# CERTIFICATE OF APPROPRIATENESS PLACARD

Remove deck; install patio; install 42" fence; install gutters and downspouts; replace front steps; install storm windows; repaint house in new colors

404 E Lane St

COA-0075-2019

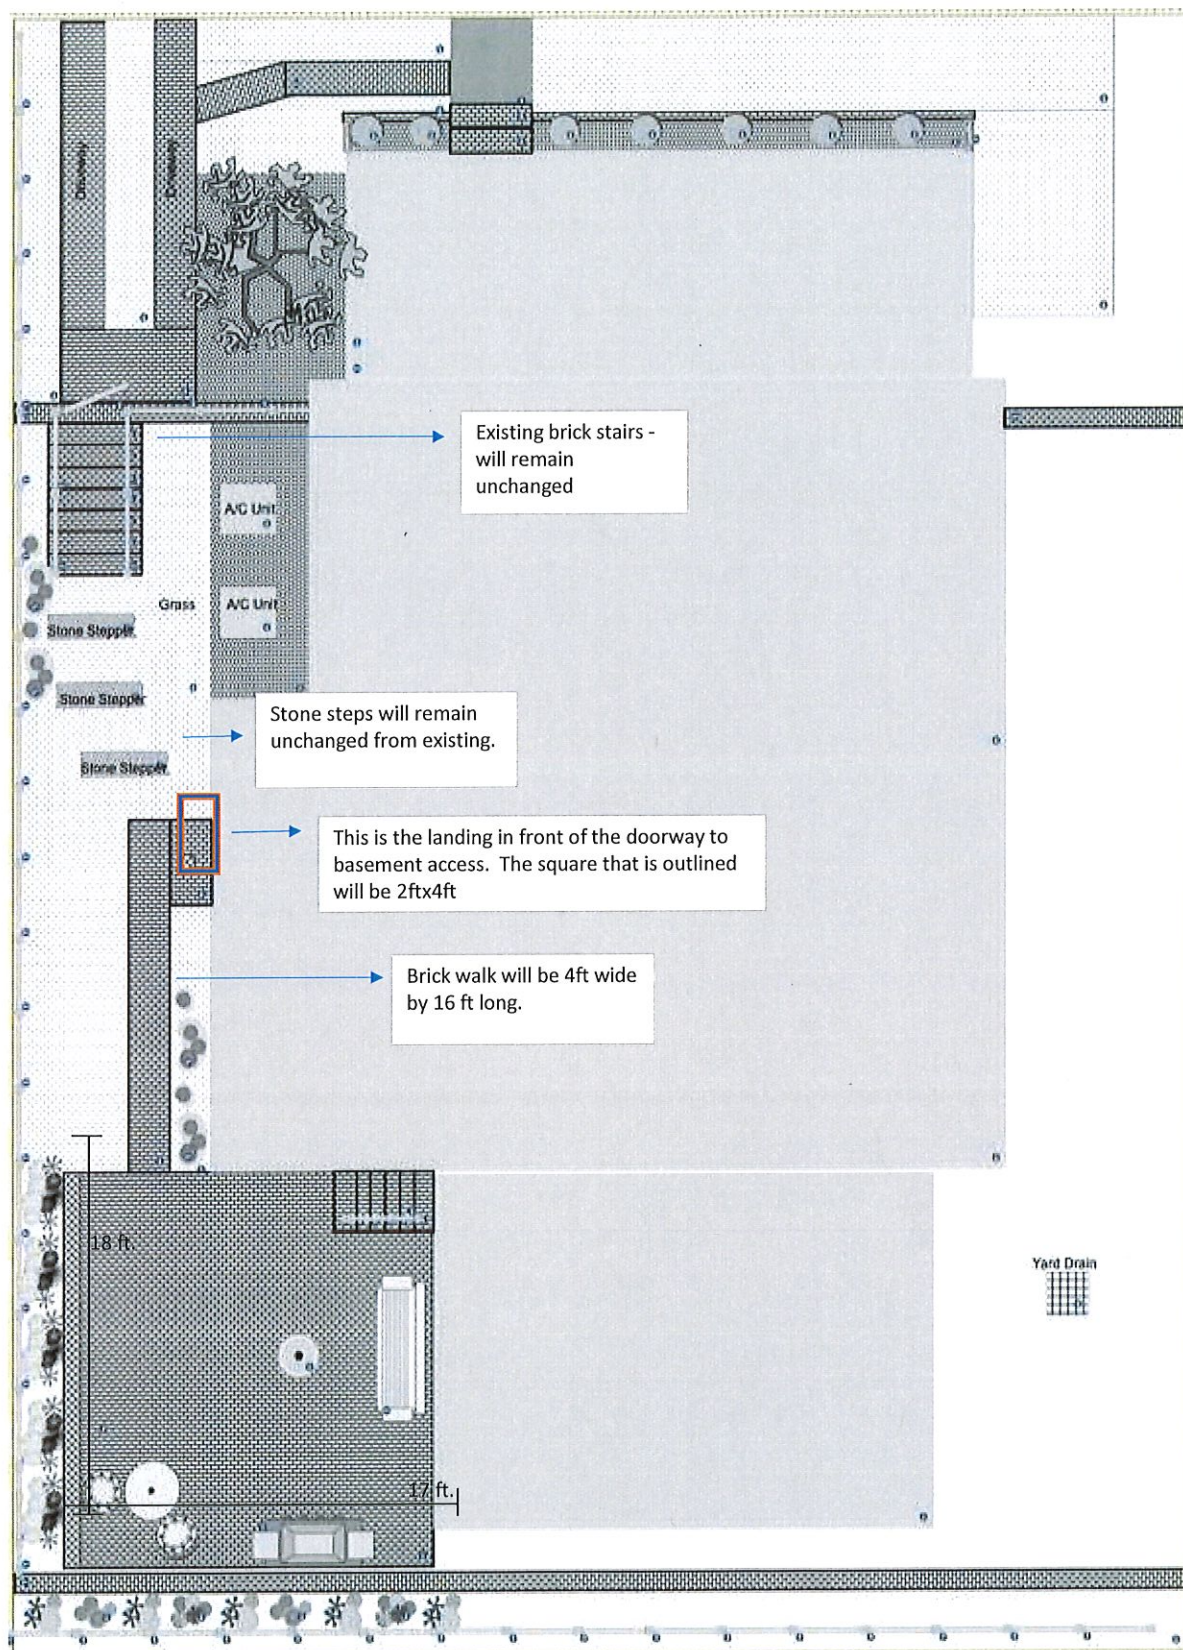
Could you also send additional images of the wooden fence(s) that you plan to replace? Based on the proposed patio drawing, it looks like your new metal fence will extend into the front yard like the current wood fence. I just wanted to double check and make sure that all of the current fencing you plan to replace is 42". It looks like it is from street view, but some of the other pictures made it appear taller. Will you also be replacing the fence that partially extends across the driveway?

We will replace all fencing. The front fence is currently at 42". Starting at the stairs from driveway to backyard, fencing descending the property line is 6ft. We do not want to have a tall fence, would like to keep height at 42" throughout. Additionally, if you reference the survey, all fencing (wood, chainlink) will be replaced with the same 42" black metal that is referenced in "fence" tab here. Survey is included with the attachments in the application.

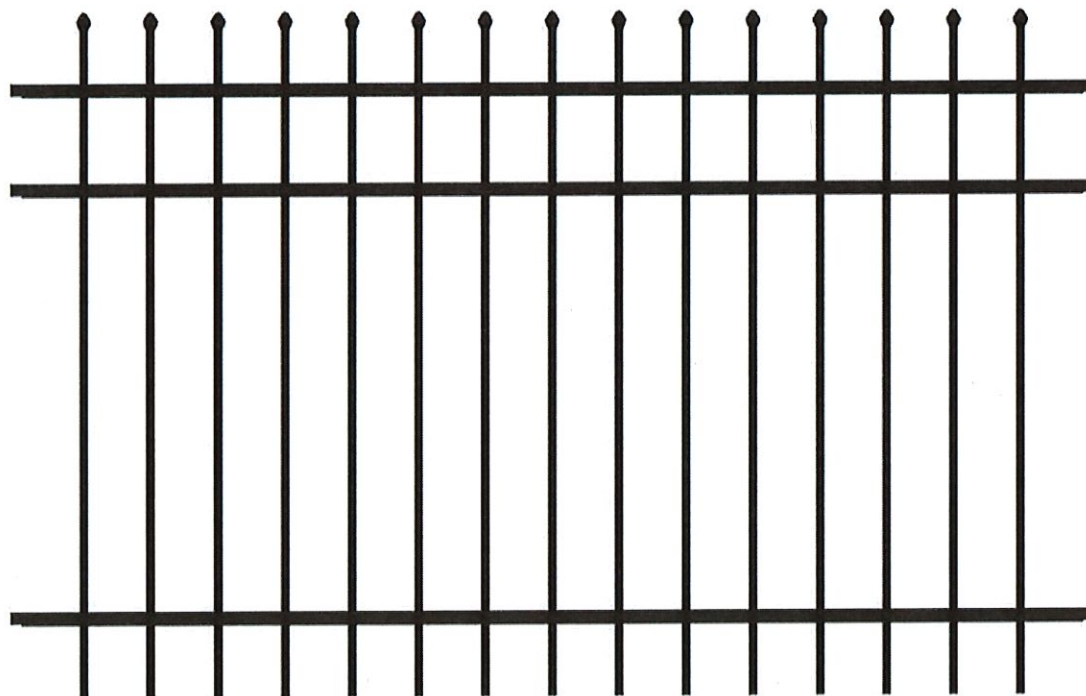
Removal of  
6' fence is  
major work  
COA.
